CLARENDON HILL: **WORKSHOP 3**

March 13, 2017

TRAFFIC & PARKING

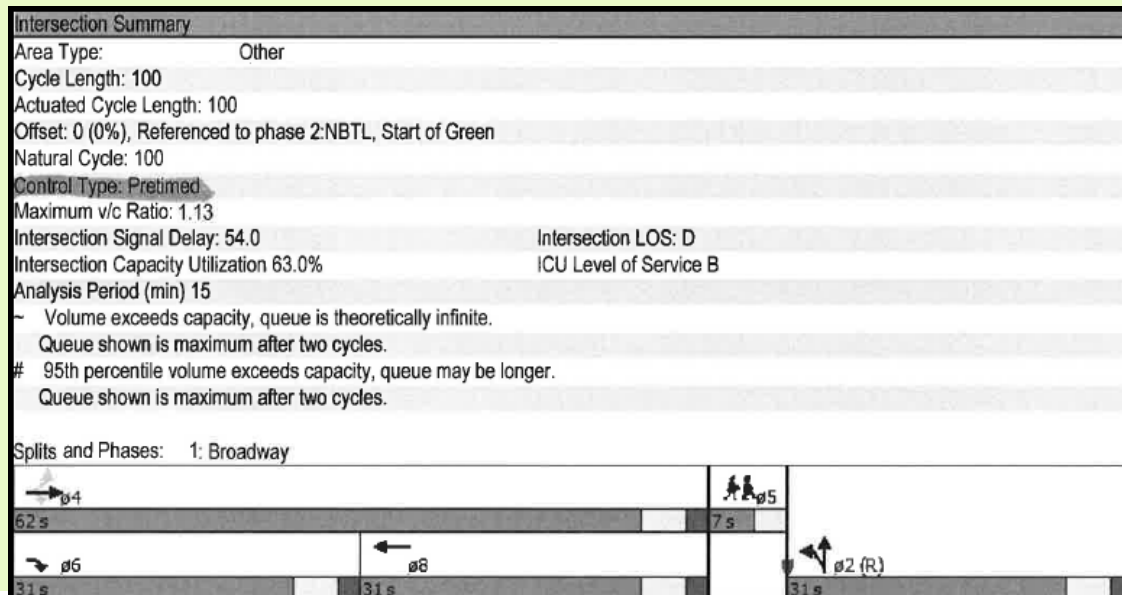
- How many bike trips down Powder House Boulevard?

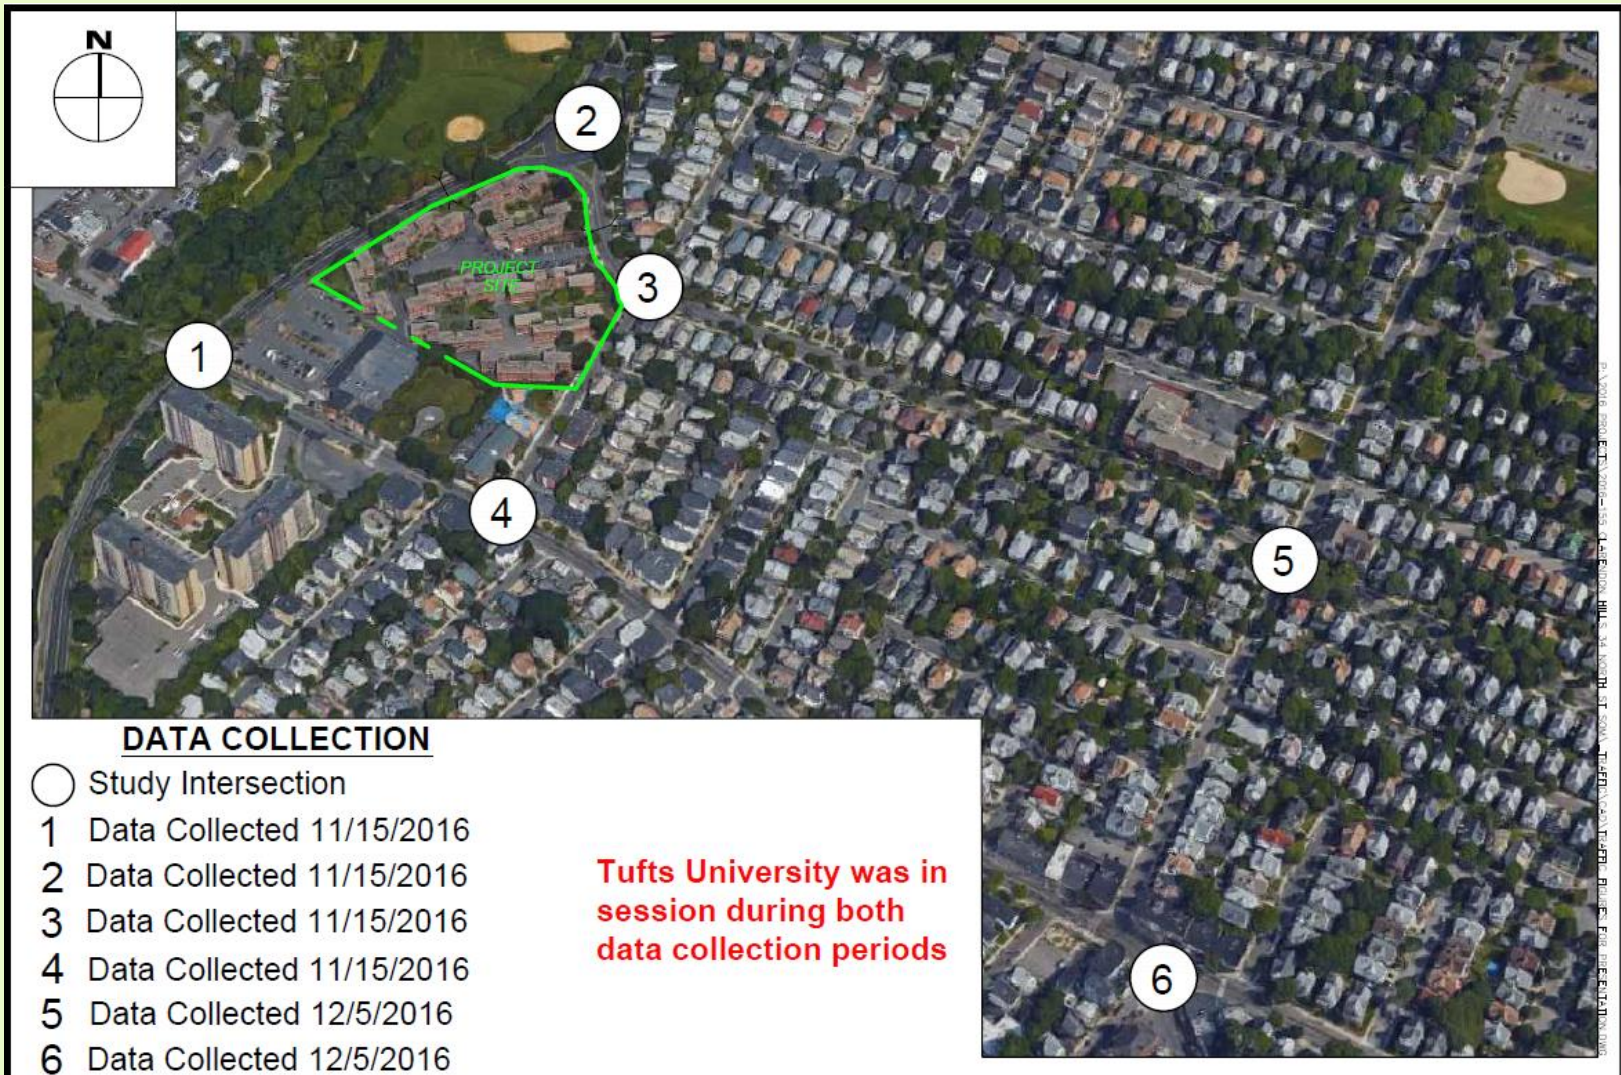
- Confirm for folks when the actual counts were taken? Was Tufts in session?
